CONDITIONS OF APPROVAL:

Engineering - PUD Plan Checklist

16. F. Development Plan

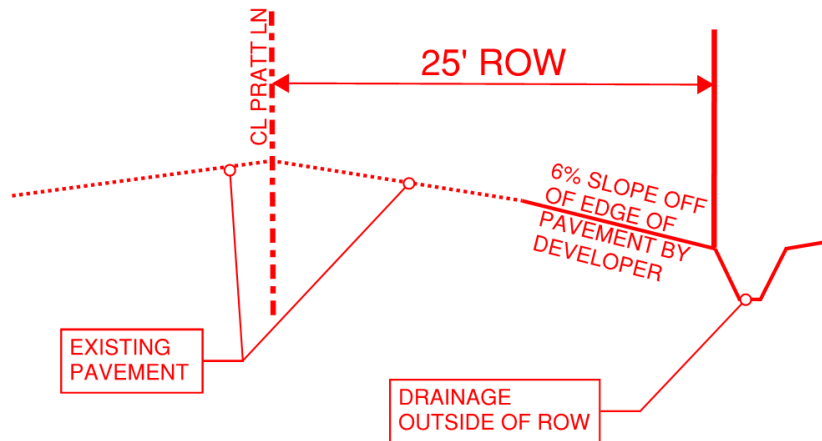
joe.marlo@franklinton.gov Comment not adequately addressed.

Applicant shall provide street lights along property frontage with Pratt Lane in accordance with Chapter 9 of the 2017 Transportation & Street Technical Standards.

35. B. General Information

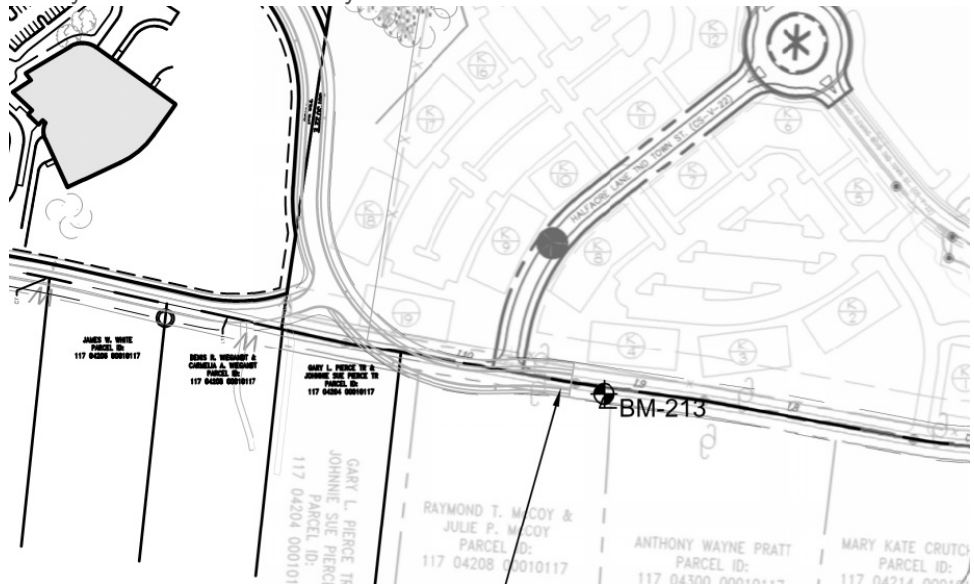
jimmy.wiseman@franklintn.gov The multi-use trail must be shown at a location that can be constructed today. Without an agreement in place with other property owners it is not yet known that the multi-use trail can be constructed along the connector road. The applicant shall show the multi-use trail along the western side of Pratt Lane.
